St. Johns River Water Management District

DATE: July 19, 2021
TO: Prospective Respondents
FROM: Amy Lucey, Sr. Procurement Specialist
SUBJECT: Addendum #3 to Invitation for Bids # 36965, S-96 Rehabilitation

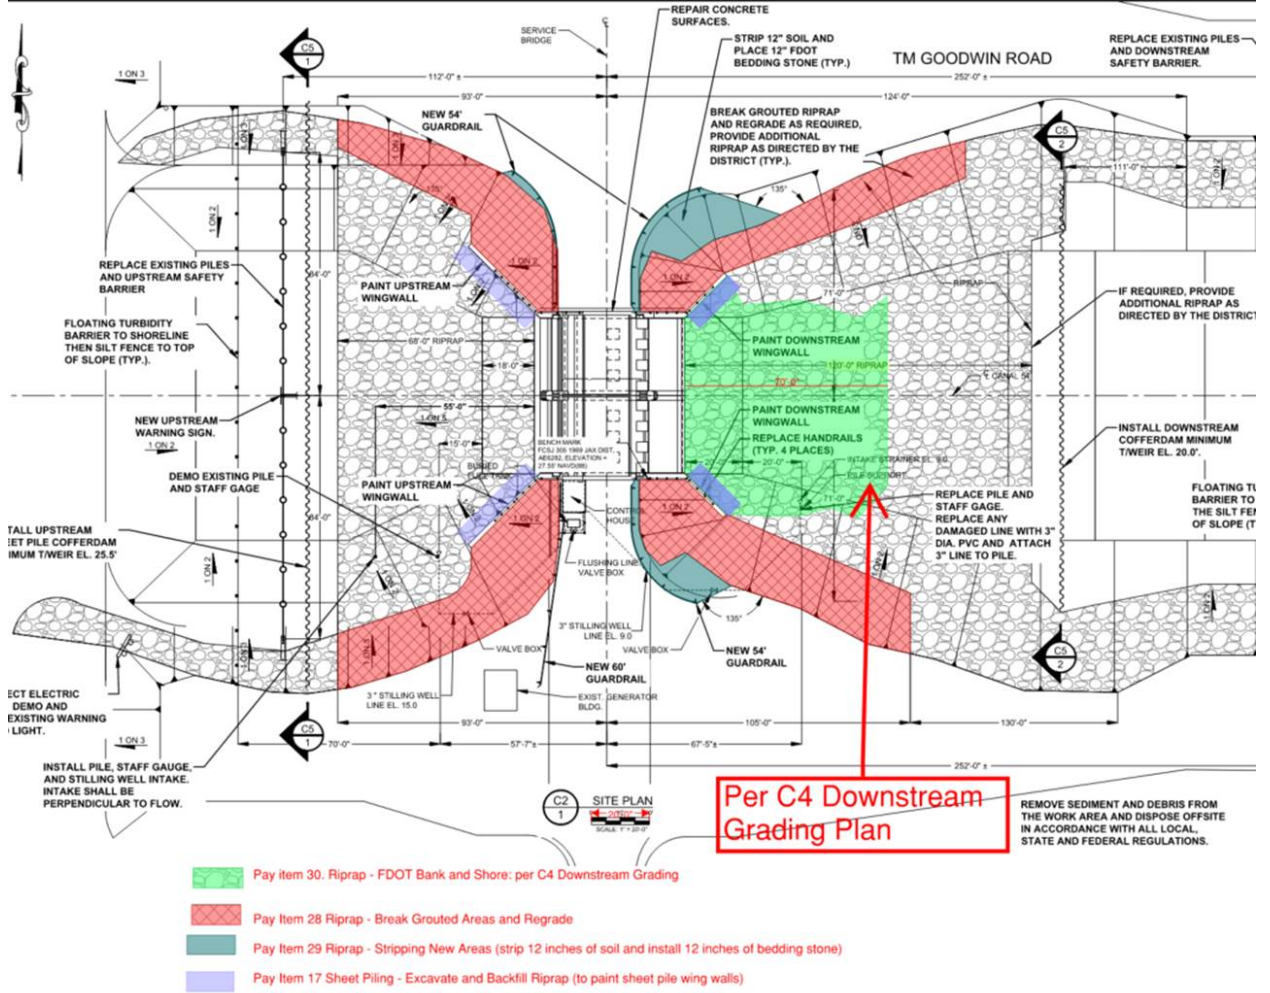
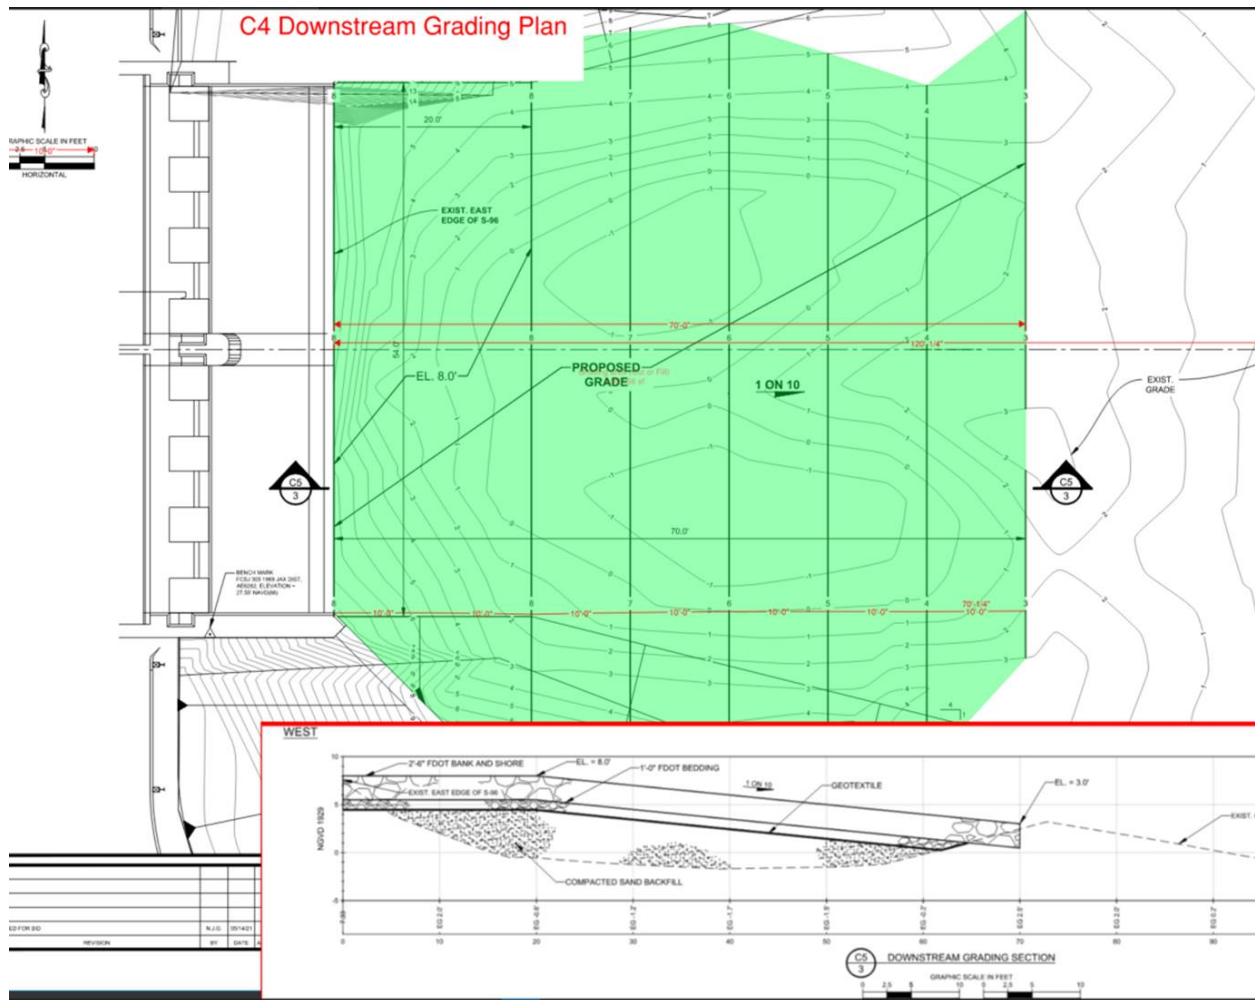
- Q4. Please provide confirmation on limits of rip rap work, see below markup.
- a. Confirm pay items 30,32,33, and 34 (depicted in light green) is the work that is to be done on existing riprap per the downstream grading plan, and that the limit of this area is 70 LF east of the existing east edge of S-96 as depicted in C5 detail 3.

- b. Please confirm that the excavated riprap/bedding stone (depicted in purple) by the sheet pile walls for pay item 17 will be reused. The district is not requesting new stone to be installed in these areas.

Confirmed. Note that although the as-builts and plans depict existing rip rap at this location, the rip rap is likely gone or has been displaced due to scour over time.

Confirmed. Existing riprap will be reused. If the existing riprap shown is no longer present, new rip rap needs to added in its place. If more riprap is needed beyond the quantities shown in the cost schedule, then additional riprap shall be supplied and installed at the unit price specified on the bid. Additional riprap, if any, can be billed under Item No. 57 SUPPLEMENTAL WORK ALLOWANCE.

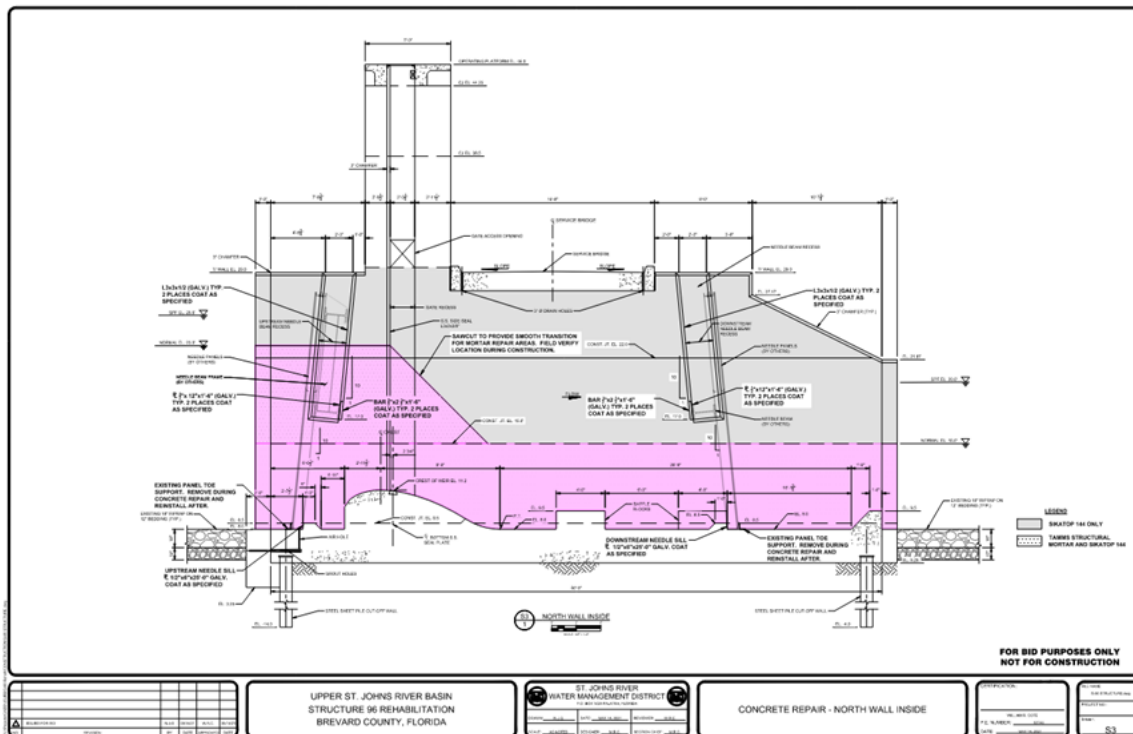
- Q10: Reference S3 and S4, the dotted area for the Tamms Mortar and Sikatop 144 ends at elevation 15.0. Is the intent for the dotted area to continue until elevation 8.0, as shown below in pink?

A10: **Yes. Delete Sheets S3 and S4 and replace with the attached Sheets S3 and S4 dated July 19, 2021.**

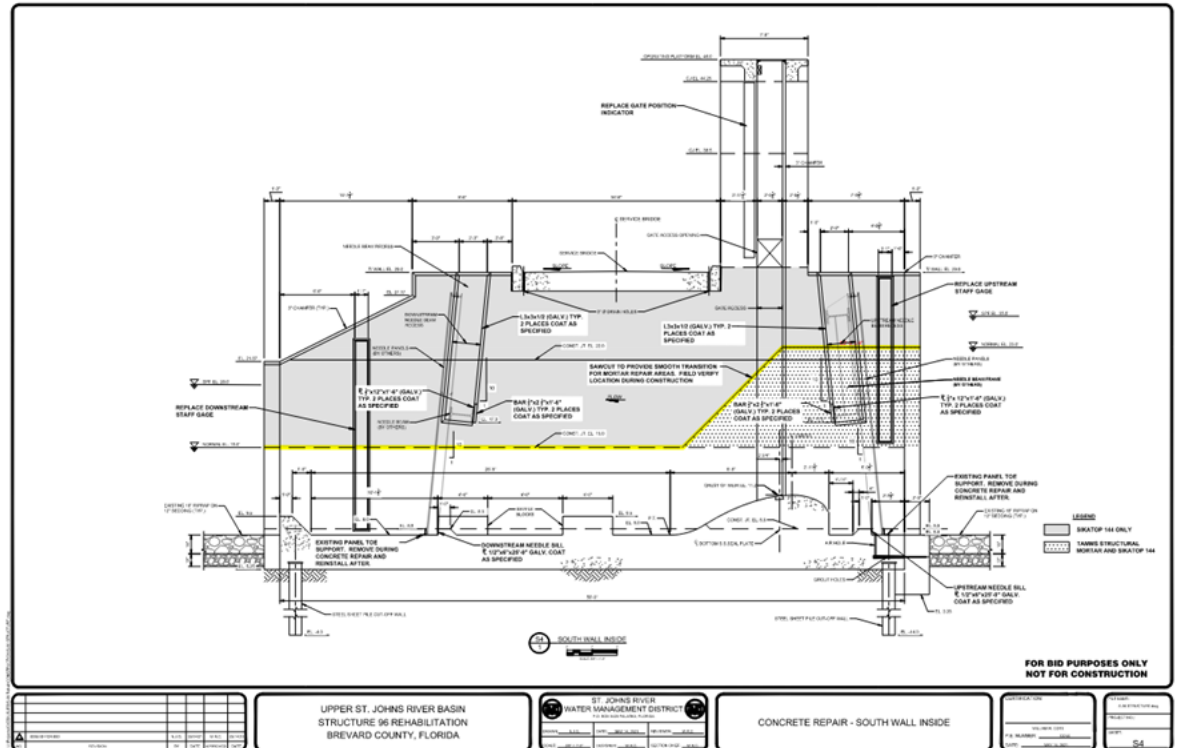
- b. Reference S3 and S4, the sawcut between the eroded surface and solid surface ends at elevation 15.0 and becomes a dotted line. Is the intent for the sawcut to continue horizontally at elevation 15.0 as shown in yellow below?

The construction joint is notched. A sawcut is not required at the construction joint.

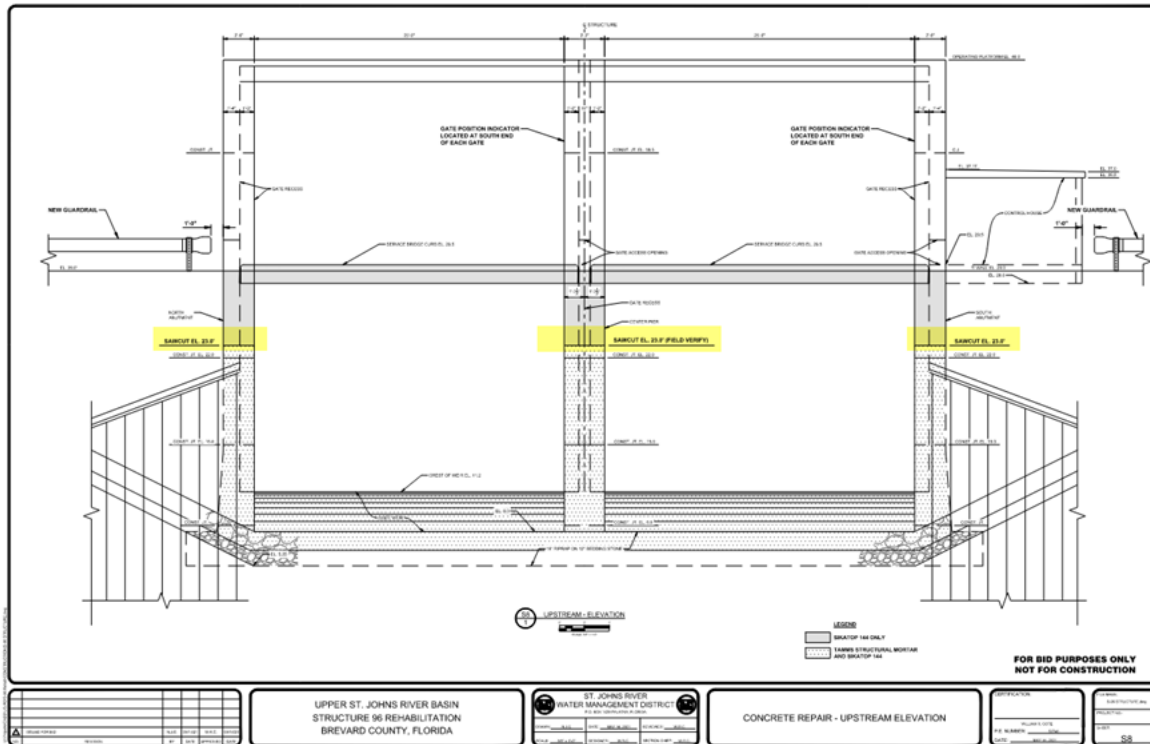
Q12: Reference S8, sawcut elevation 23.0. What depth shall be required for the sawcut between the eroded surface and sound concrete surfaces?

A12: **The depth of sawcut should be about the same as the depth of the eroded surface.**

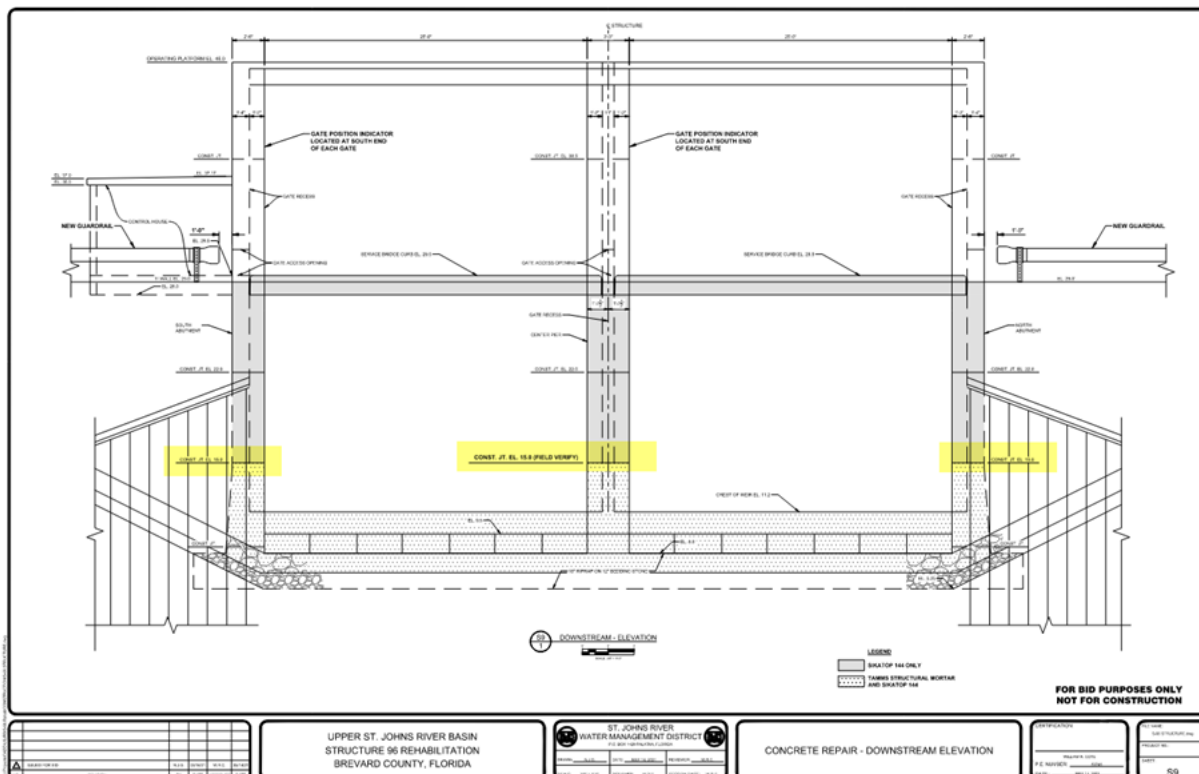
Q13: Reference S9, the construction joint at elevation 15.0. Is the intent for the south and north abutments and the center pier to be sawcut at elevation 15.0 and what is the depth of sawcut?

A13: **The construction joint is notched. A sawcut is not required at the construction joint.**
